MARINA PARK GROUP PICNIC AREAS PROJECT NO. 11-150-62-107

ADDENDUM NO. (1)

September 10, 2012

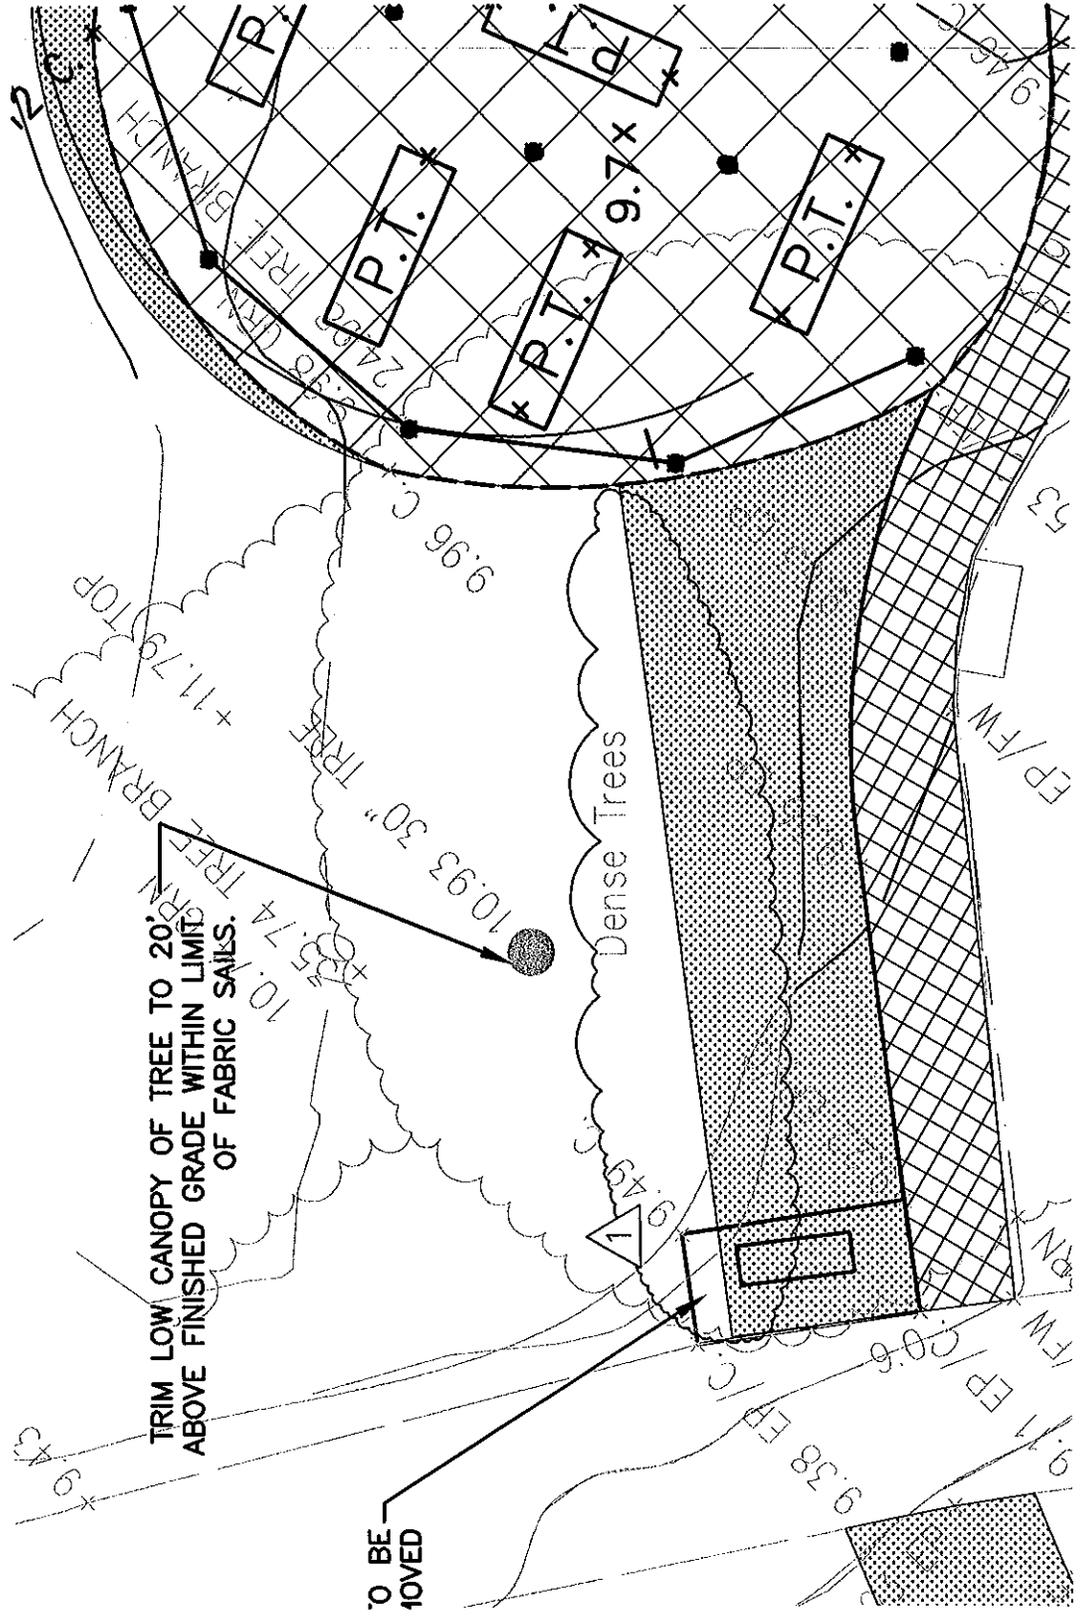
1. Sheets D2 and C2 revised – See attached excerpts which include the following revisions:
 - o Change detail callout note on Mallard Picnic to be 6/CD1.
 - o Increased clear and grub and finished grade area at access path to Mallard Picnic area.
